Re: DeSabra-Centerville (FERC Project #803) Comments on Remaining Study Results

Re: DeSabra-Centerville Hydroelectric Project Water Temperature Modeling

Subject: Review Comments on CE-QUAL-W2 Models for DeSable Relicensing Project – Forest Service Agreement No. 08-IA-11050650-016

Figure 1. Centerville Canal W2 model error during the summer and early fall in the 2004 calibration simulation.

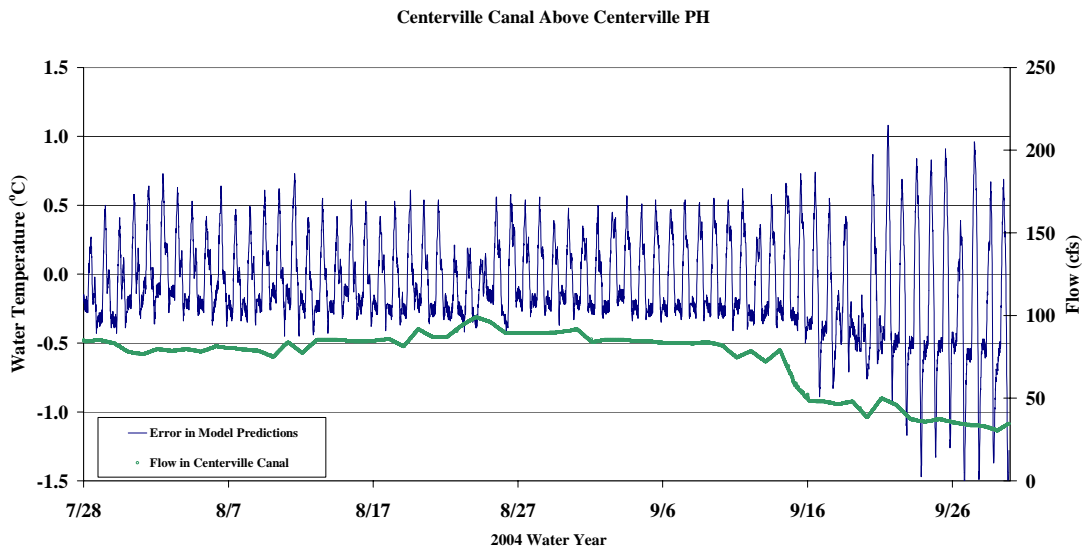
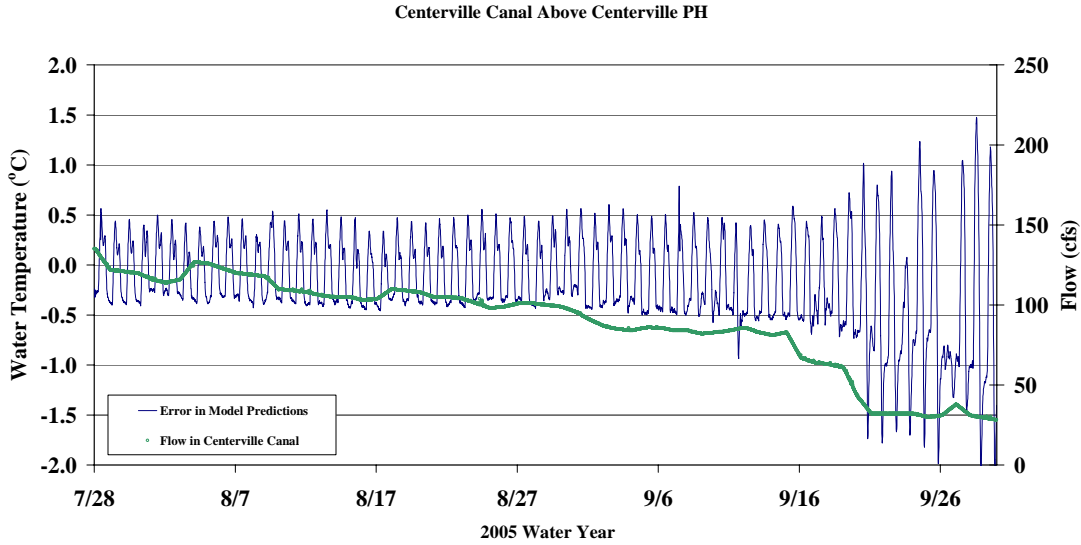
Figures 1 and 2 depict model¹ error vs. canal flow for the Lower Centerville Canal during the last half of the 2004 and 2005 calibration years, respectively. As can be seen for both the 2004 and 2005 calibration years, model error generally increases beyond $\pm 1^\circ\text{C}$ at flows below about 35 cfs. We also note that this pattern of increased model error seems to occur during the mid- to late-September period during both calibration years. The range of flows used in the calibration simulations was between about 28 cfs and 160 cfs. Therefore, we recommend that the Lower Centerville Canal model only be used to evaluate the differences in operational scenarios with flows between 35 cfs and about 160 cfs. In addition, the simulation period should be limited to early-June through mid-September.

- The models should be used for comparative purposes only (i.e. to compare the difference between operational alternatives);
- The Lower Centerville Canal model can be used to evaluate scenarios that include diversion flows between 35 cfs and 160 cfs. The simulation period should be limited to early-June through mid-September;
- The Hendricks Canal model can be used to evaluate scenarios that include diversion flows between 43 cfs and 236 cfs; and
- The lower Butte Creek model can be used to evaluate scenarios that include flows below the Centerville Diversion Dam between 24 cfs and 118 cfs.

Figure 3. Butte Creek W2 model predictions and observed temperatures during early summer in the 2004 calibration simulation.

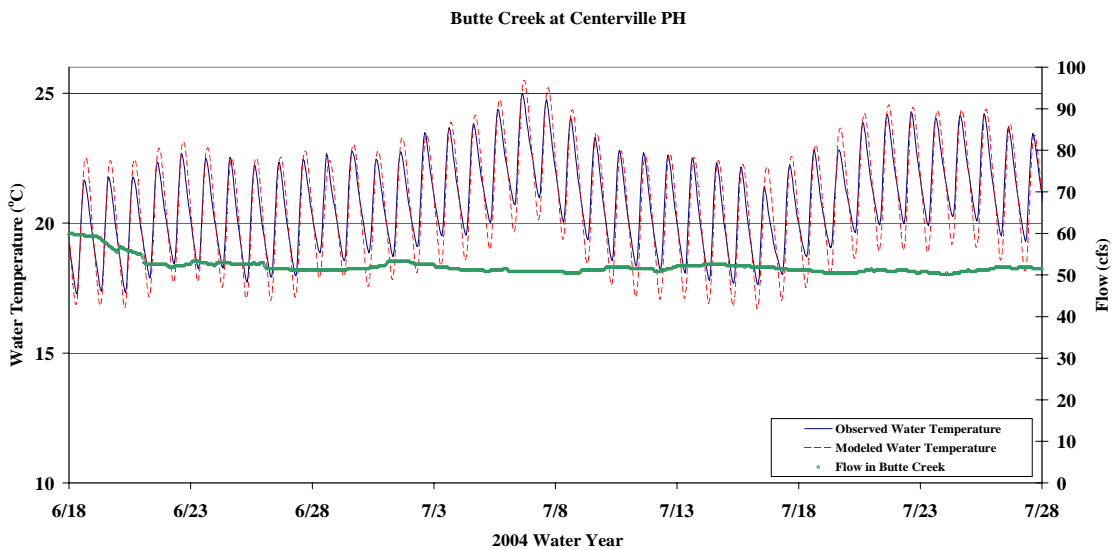
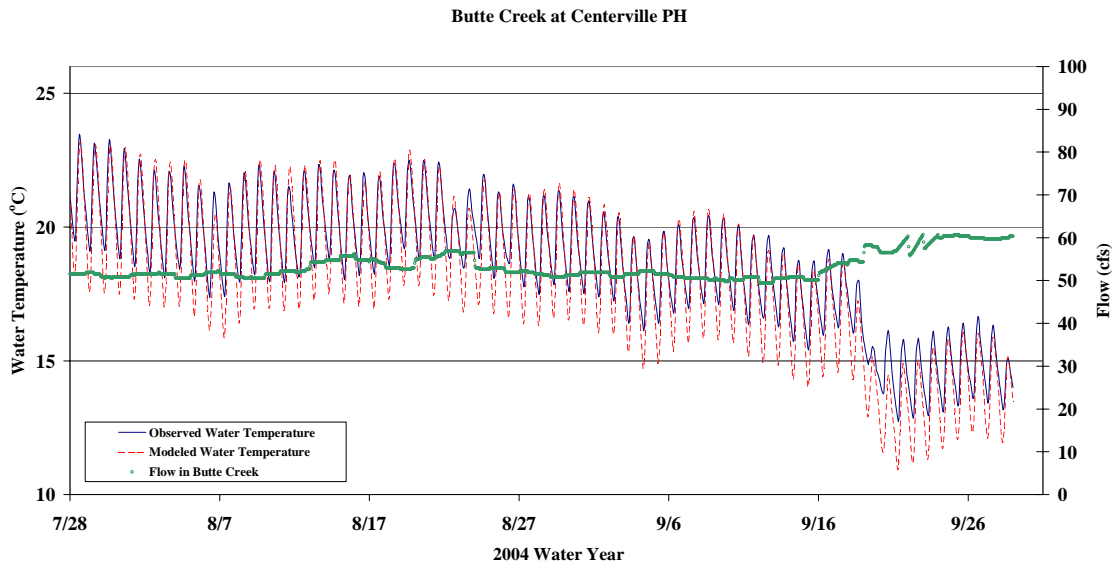
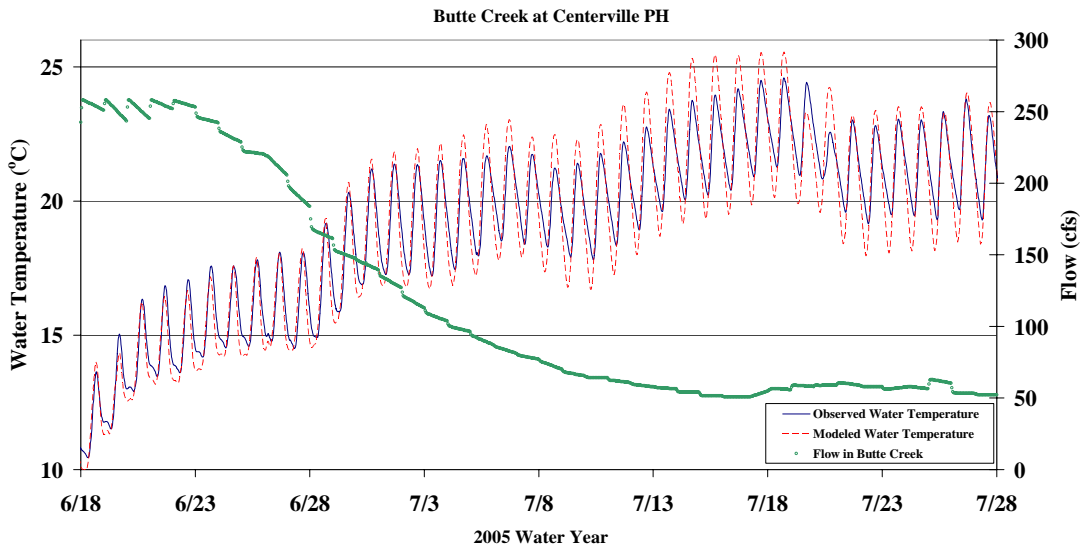
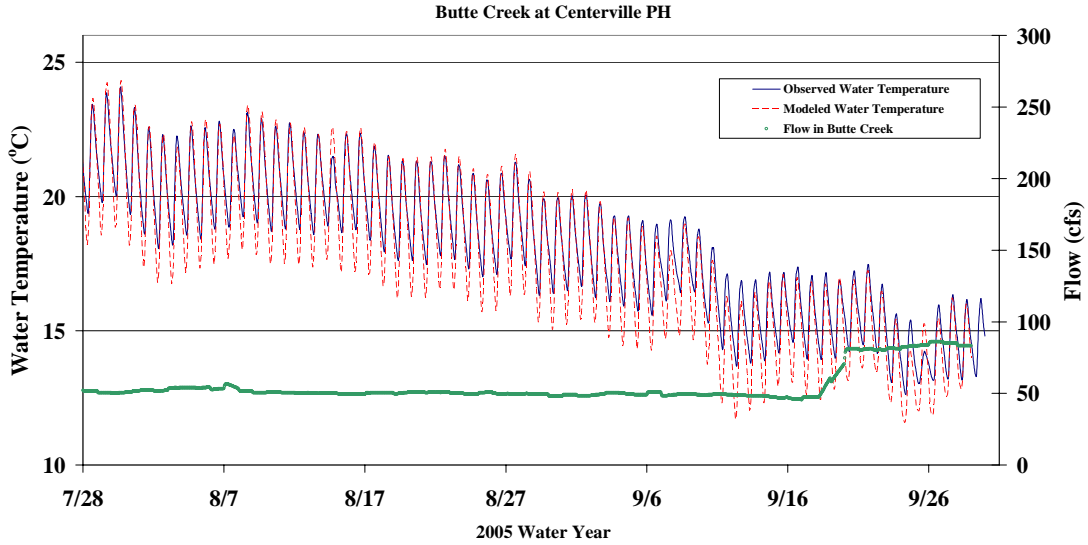
Figures 3 through 6 compare model output data, observed data, and flow data for lower Butte Creek during the 2004 and 2005 calibration years. As can be seen in both the 2004 and 2005 calibration years, the models appear to be specifically calibrated in an attempt to match maximum peak temperatures; however, the models appear to sacrifice accuracy with regard to the total amount of diurnal fluctuation and minimum temperatures. During the 2004 and 2005 calibration simulations, the flows in Butte Creek below the Centerville Diversion Dam ranged from about 43 cfs to about 236 cfs. Therefore, we believe that the models should be used to evaluate the differences in operational scenarios with flows between 43 cfs and about 236 cfs.

Figure 7. Hendricks Canal W2 model predictions and observed temperatures during the early summer in the 2004 calibration simulation.

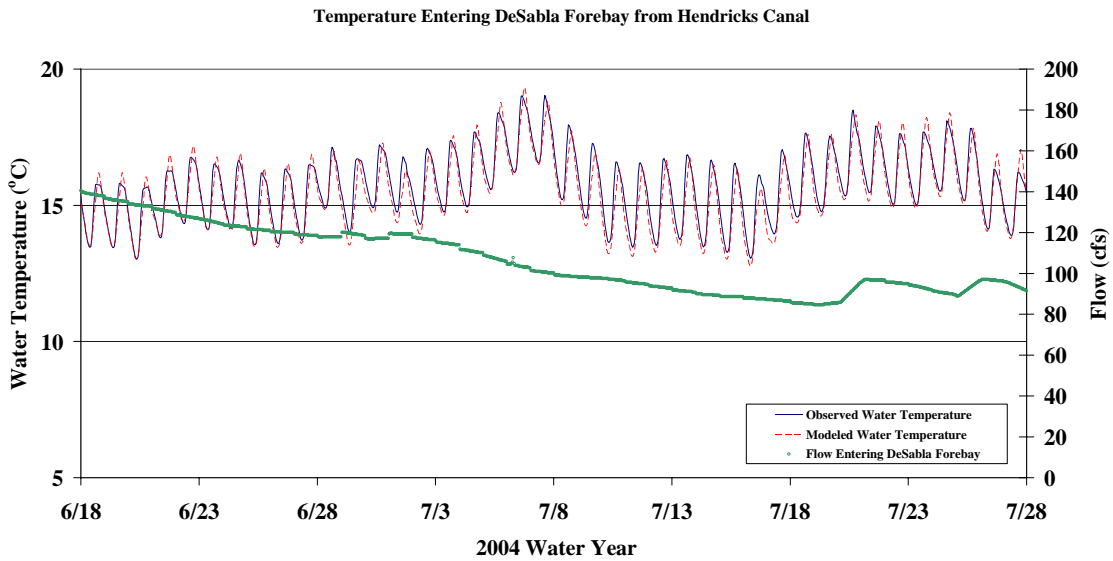
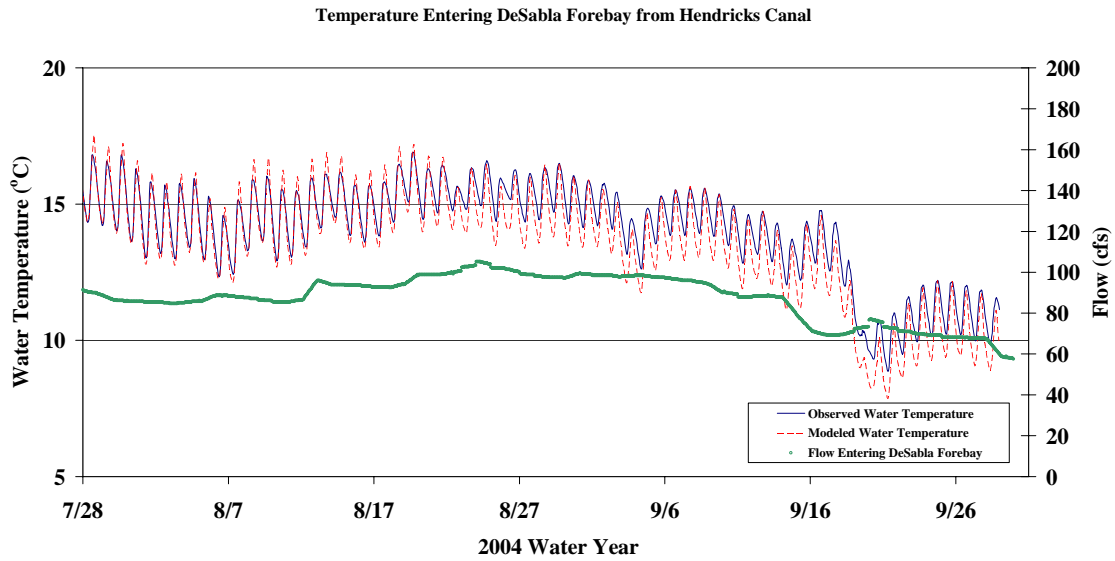
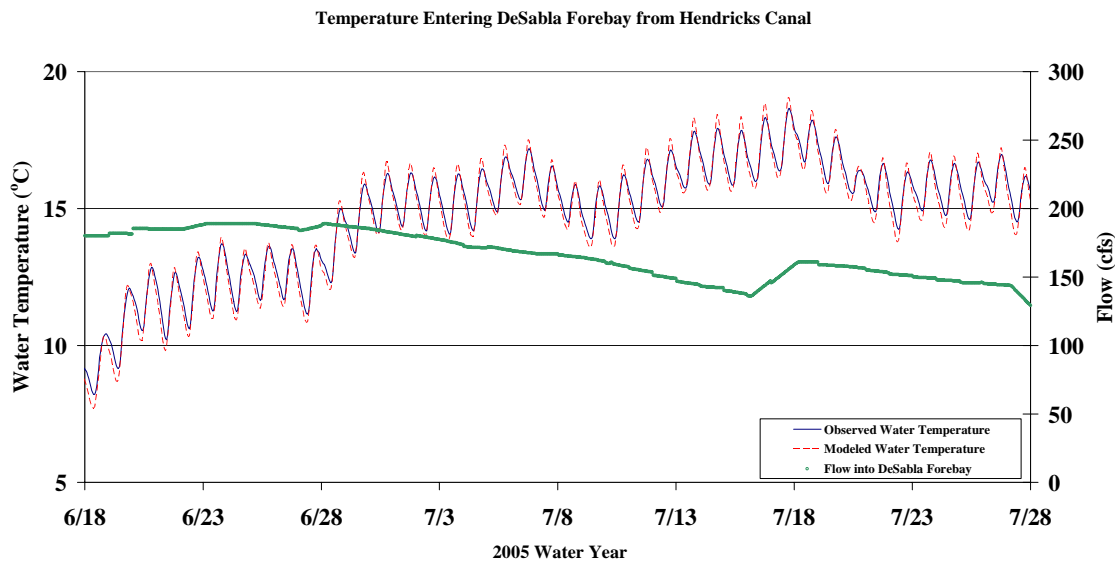
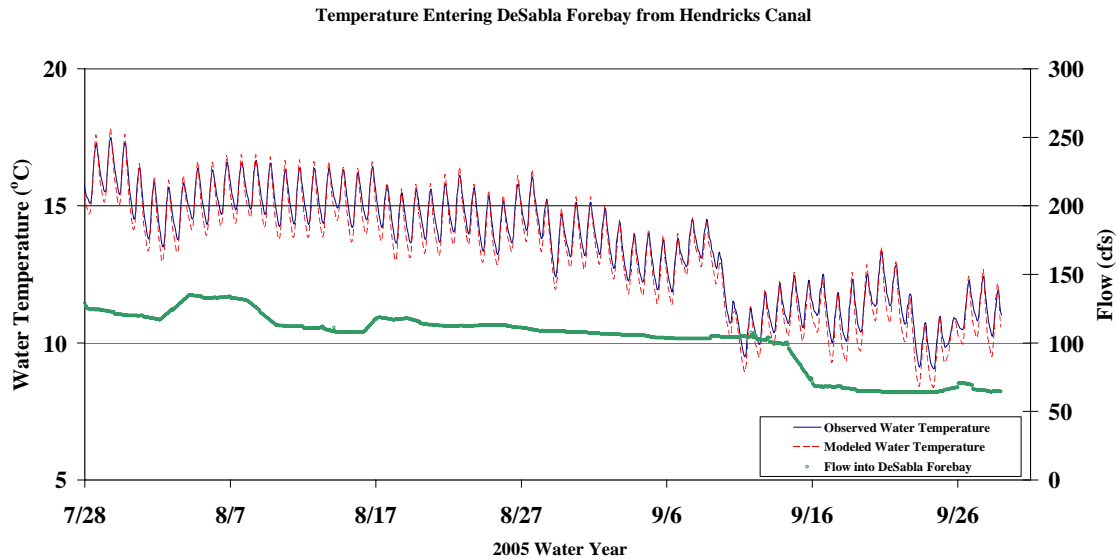
Figures 7 through 10 compare model output data, observed data, and flow data for the Hendricks Canal during the 2004 and 2005 calibration years. Similar to the lower Butte Creek models, the Hendricks Canal models appear to be specifically calibrated in an attempt to match maximum peak temperatures, and they appear to sacrifice accuracy relative to the total amount of diurnal fluctuation and minimum temperatures. During the 2004 and 2005 calibration simulations, the diverted flows ranged from about 24 cfs to about 118 cfs. Therefore, we believe that the models should only be used to evaluate the differences in operational scenarios with flows between 24 cfs and about 118 cfs.

Figure 11. 2005 temperature model predictions at the downstream end of the WBFR model.

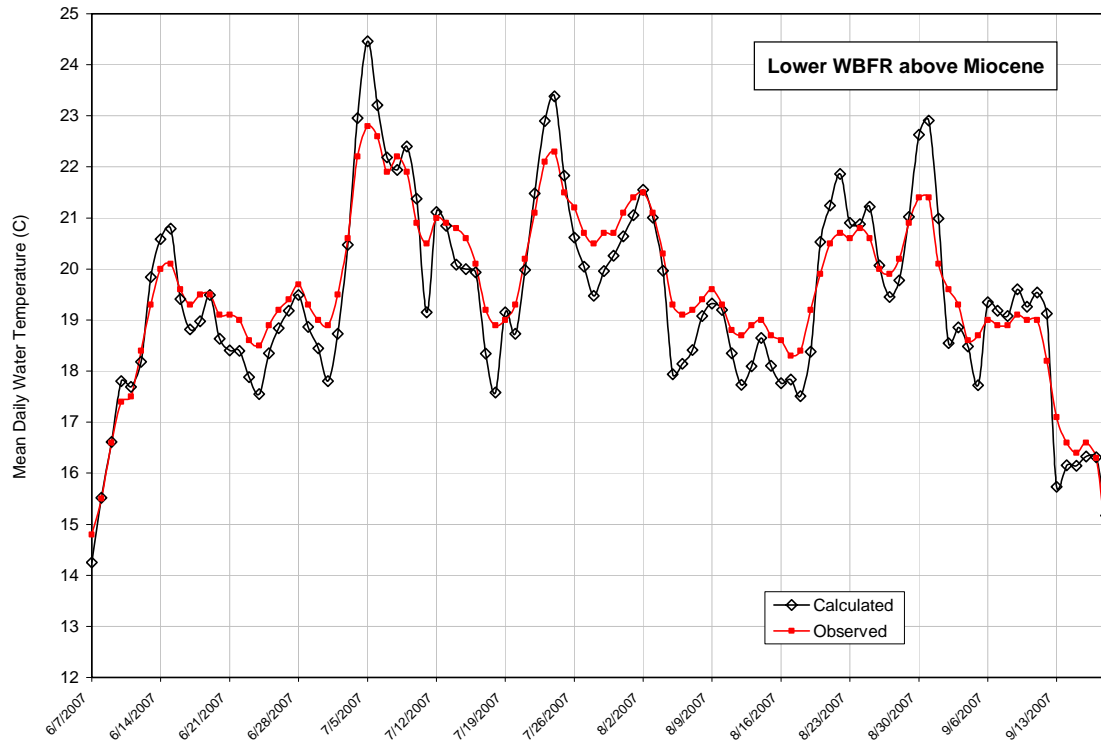
The Licensee did choose to revise the WBFR model in 2007. After the model was already calibrated/validated, the Licensee continued to collect data during 2007. When the field data for this dry year was input into the Lower WBFR model, the model did not meet the Licensee’s calibrations guidelines. The Licensee therefore developed a specific model for the WBFR during dry year conditions. In this model, the Licensee used a one-day lag in hydrology input conditions; this approach helped the Licensee bring the 2007 WBFR model’s performance to “near or within” their calibration criteria, however the model still continued to exhibit the exaggeration in temperature predictions. This trend is illustrated in Figure 11 below, which shows the measured and modeled temperatures at the Miocene diversion, on the downstream end of the Lower WBFR model.

- The models should be used for comparative purposes only (i.e. to compare the difference between operational alternatives);
- The West Branch Feather River model can be used to evaluate scenarios that include Dam release flows above 8 cfs;
- The Upper Butte Creek model can be used to evaluate scenarios that include Dam release flows above 19 cfs.

Figure 12. 2005 temperature model predictions at the downstream end of the Upper Butte Creek model compared to flow releases (and spill) from the Butte Head Dam.

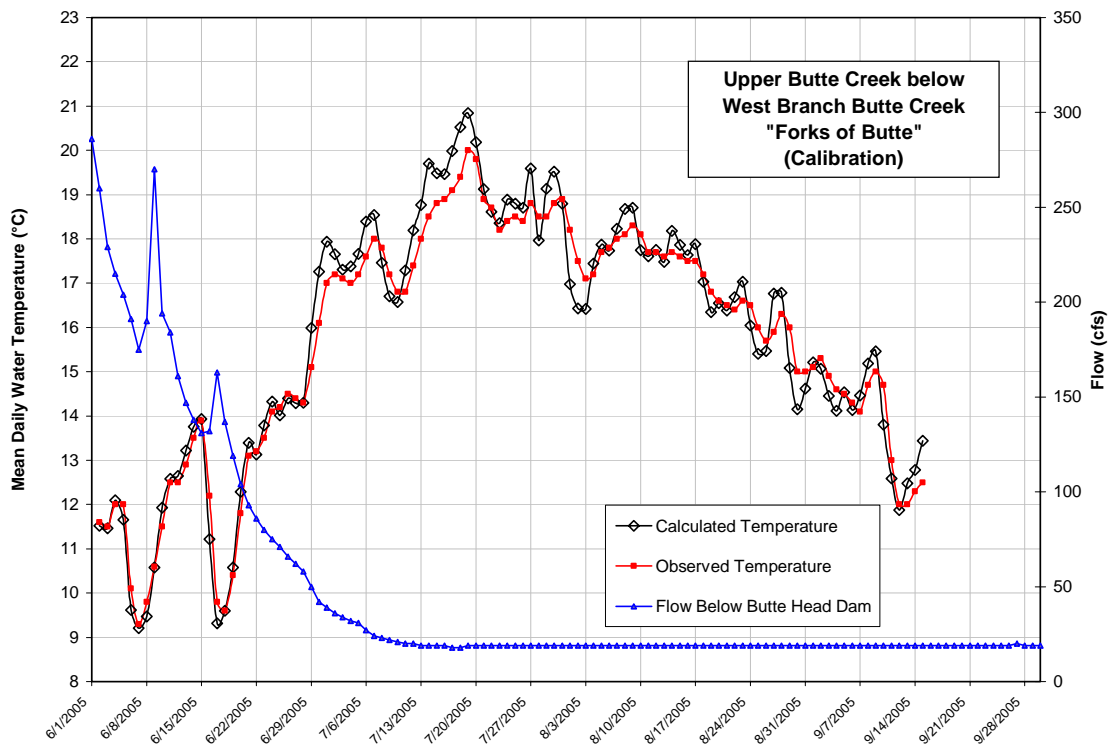
The hypothesis that the models perform poorly because of the low flow conditions is supported by consideration of the results of the one calibration model run that contains both high and low flows. Because releases are controlled at Butte Head dam and the Hendricks Head Dam, mostly only lower flow conditions were seen in the rivers during the simulation periods. However, during 2005 in the Upper Butte Creek model, higher flows were observed, and Figure 12 below shows that when flows at the top of the Upper Butte Creek reach were above about 50 cfs, the model performed well.

Figure 13. 2005 temperature model predictions at the downstream end of the Butte Canal model.

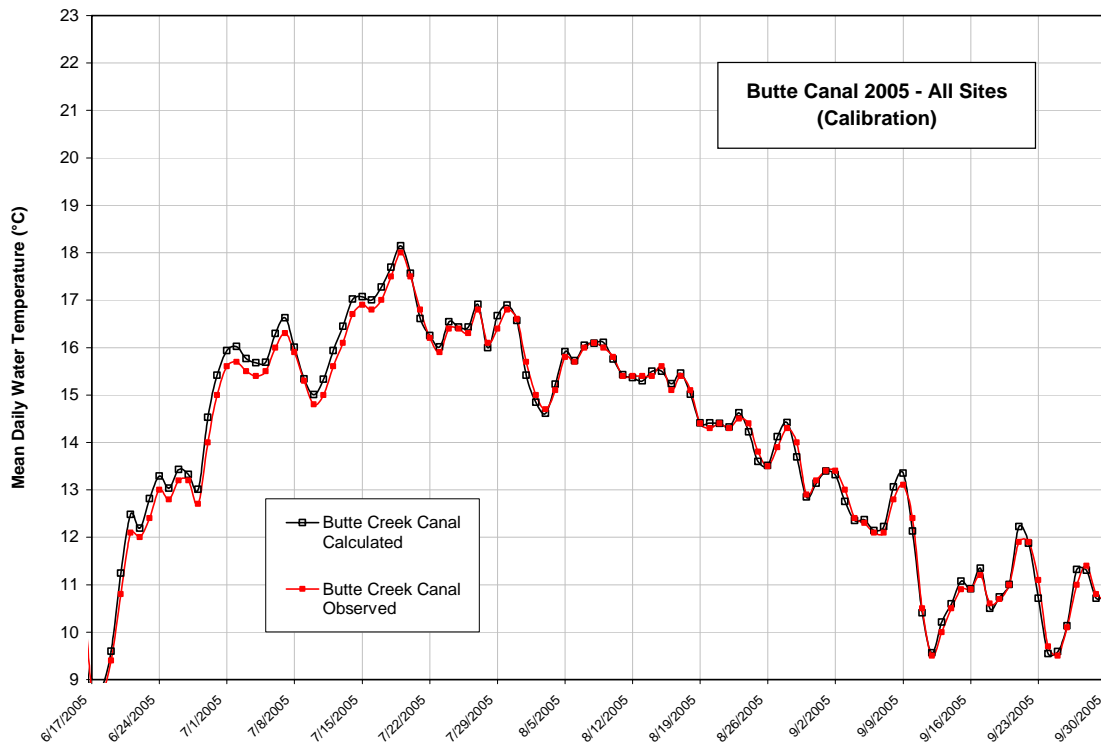
We also reviewed the Butte Canal model. The geometry in this model was represented simply as a rectangular channel, and this is probably not accurate. A more appropriate width versus flow relationship could be developed. However, the Butte Canal model does a good job predicting water temperatures throughout the summer at Dam release flows of 40-75 cfs. We recognize that there may be a lower limit on the ability of the model to accurately predict temperatures at very low flows, but we have no way to determine a lower limit on the model’s range. While we don’t have any specific recommendations for changes or limits on this model, we would caution that using this model for predicting water temperatures at flows much below 40 cfs is outside of the range of calibration. The performance of the Butte Creek model during the calibration year, 2005, is shown in Figure 13 below.

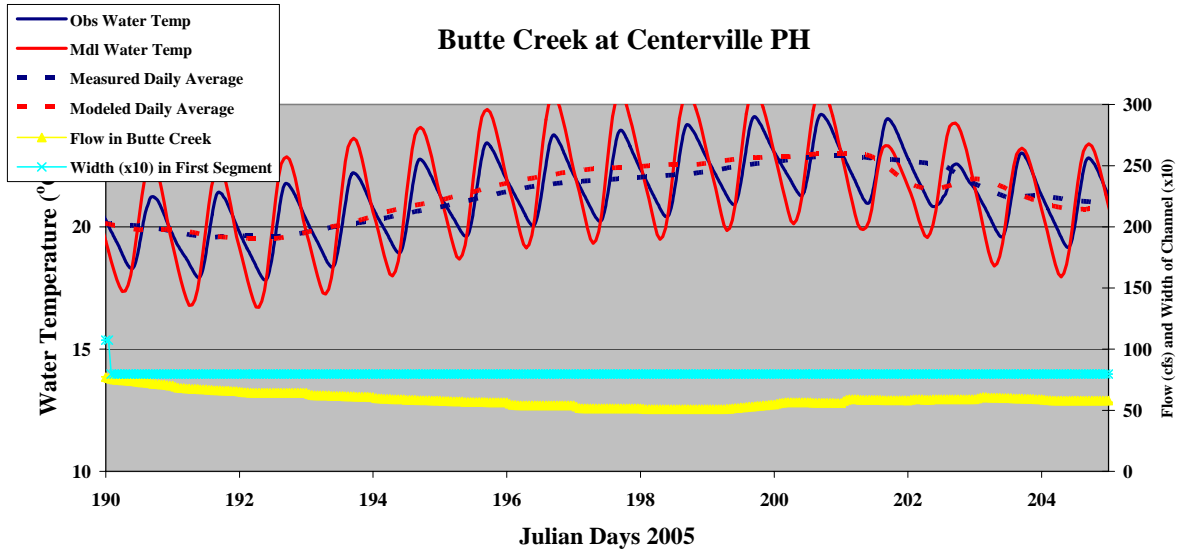
- 6) One of the concerns has been that the Butte Creek W2 model over-predicts warm maximum temperatures and under-predicts minimum temperatures as shown in the following draft figure of W2 model results plotted against observed data (received from Beth Lawson, CA F&G, EXCEL spreadsheet 2005 Butte Creek Temp recalibrated2.xls, based on two_95.opt file, March 13, 2008). Spot checking the w2 version 3.2 outputs with W2 vs. 3.5 model outputs showed similar warm maximum temperatures. If recent data and modeling shows a better calibration, similar figures should be produced. Much can potentially be discovered from the following figure that is titled Butte Creek at Centerville PH. More damping is seen in pools than on riffles suggesting that this W2 model is indicative of riffle conditions rather than more pool-like conditions observed in the field. More modeled riffles results in less water travel time in the pools. Diurnally, a riffle will warm and cool to a greater extent. A riffle bed exposed to solar radiation will trap bed heat and warm water flowing over the riffle into the evening hours creating a lag in water temperatures. Of greater concern on the following figure are water temperatures above 22°C (71.6°F) at roughly 1.5 (cms) (53 cfs). Such warm temperatures are too warm for anadromous or cold water fish. There is no room for error if operations under 1.5 cms (53 cfs) are anticipated. Most temperature modeling of steep reaches results in too much diurnal bounce due to modeled pool volumes being too small. The result almost always points to poor geometry used in a model resulting in not capturing the pool volume accurately. Adding pool volume to a steeply modeled reach that over- and under-predicts water temperature due to factors such as bed heat transfer and lag not being modeled accurately might be considered.
